**US 36/US 68 Intersection Improvement (ODOT PID #103793)
Addendum #1**

To: All Bidders
From: Tyler Bumbalough; City of Urbana Engineer
Date: January 28, 2019
Re: Addendum #1

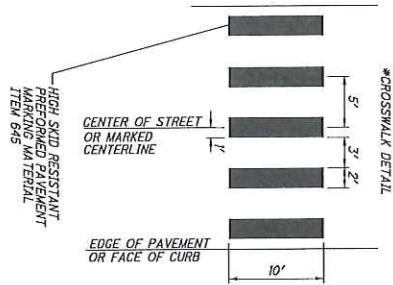
Q: I understand that this project is the first phase of improvements at this intersection so there is removal of pavement markings and Item 642 for the pavement markings prior to the next phase that involves resurfacing. Sheet 66 of 83 contains the pavement marking legend but the item types listed are 644 and 645 which differ from the bid sheet and the rest of the plans. I assume these should all be Item 642?

A: The markings shall be 642 (Traffic Paint). All other sheets including the general summary and cost estimate show 642. The legend on sheet 66 has been updated and is being provided as part of this addendum. The updated sheet 66 shall supersede the previous version.

PAVEMENT MARKING LEGEND	
(24)	ITEM 642, CENTER LINE, DOUBLE YELLOW
(25)	ITEM 642, EDGE LINE, WHITE
(26)	ITEM 642, EDGE LINE, YELLOW
(27)	ITEM 642, CROSSWALK, WHITE*
(28)	ITEM 642, CHANNELIZING LINE, WHITE
(29)	ITEM 642, FIELD LINE, WHITE
(30)	ITEM 642, STOP LINE, WHITE
(31)	ITEM 642, TRANSVERSE LINE, YELLOW
(32)	ITEM 642, PARKING LINE, WHITE
(33)	ITEM 642, CENTER LINE, DASHED YELLOW
(34)	ADDENDUM #1 1/24/19
